## CDM: Recommendation Form for Small Scale Methodologies (version 01)

<b>Date of SSC WG meeting:</b>	10–12 November 2008, SSC WG 18
<b>Title/Subject (give a small title or specify the subject of your submission, maximum 200 characters):</b>	Clarification request on the applicability of AMS-III.H to a project activity at a waste water treatment plant in Mexico
<b>Indicative methodology to which your submission relates (refer the items of Appendix B of the Simplified Modalities and Procedures), if applicable.</b>	AMS-III.H version 09
<b>Name of the authors of the query:</b>	Matthias Müller Institution: Green Gas Germany GmbH matthias.mueller@greengas.net

The aim of the treatment is the decrement of the organic load of the wastewater. The recovered gas (500 m<sup>3</sup>/h) is vented into the atmosphere. The figure below describes the baseline boundary:

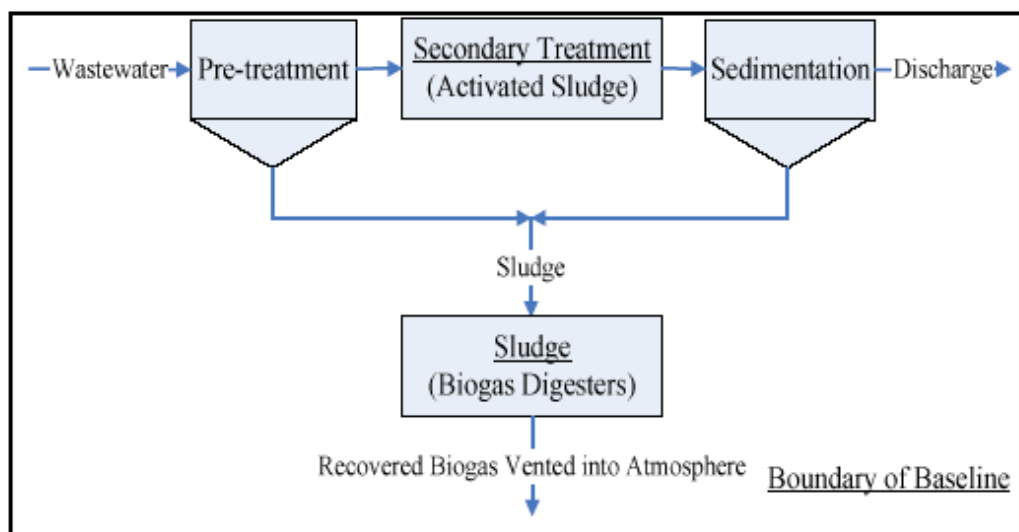
The SSC WG understood that the described project activity in the baseline situation has the equipment and facility to recover the biogas from the sludge treatment system, however lacks the equipment and facility to flare the recovered biogas and/or use it.

Venting biogas to the atmosphere without flaring is not a common practice, as it will be then a source of odour and carries a risk of fire/explosions in wastewater treatment plants. The SSC WG agreed to request further clarification on the baseline condition, particularly the valid reasons for which flaring is not done if any. The Project Proponent may also wish to propose guidance in the methodology to test those conditions to establish the baseline for example is the situation foreseen in the engineering design of the wastewater treatment? For what reason was a flare not included in the design, or for what reason is it not operational? Further, there may be a need to specify a certain extent of historic data (e.g. for the last three years if the sludge treatment system has been operational for more than three years, otherwise for the duration for which the sludge treatment system has operated) to establish the baseline.

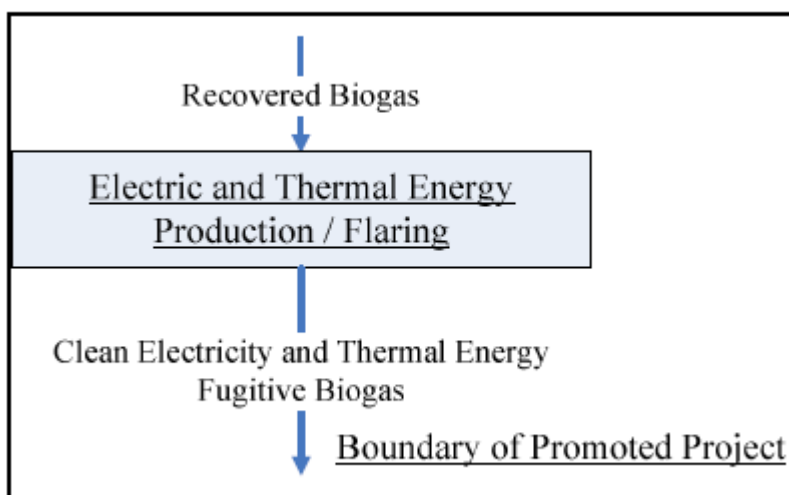
According to its paragraph 1 (iii) the methodology AMS-III.H is applicable to project activities which introduce a methane recovery and combustion to an existing sludge treatment system. The Project Proponent kindly request guidance on the applicability of current version of AMS-III.H to the situation mentioned above, where the sludge treatment and biogas recovery takes place in the baseline and the project activity will introduce combustion and utilization measures of the biogas. Furthermore if expedient and in conjunction with the project activity illustrated above the Project Proponent are seeking guidance on potential subsequent steps to be undertaken on the AMS-III.H (e.g. deviation/extension/revision of the AMS-III.H.).

AMS-III.H version 10 is applicable to project activities, which introduce ‘methane recovery and combustion’ to an existing sludge treatment system. The SSC WG agreed to clarify that AMS-III.H version 10 treats methane recovery and methane combustion as an inter related and integral activity.
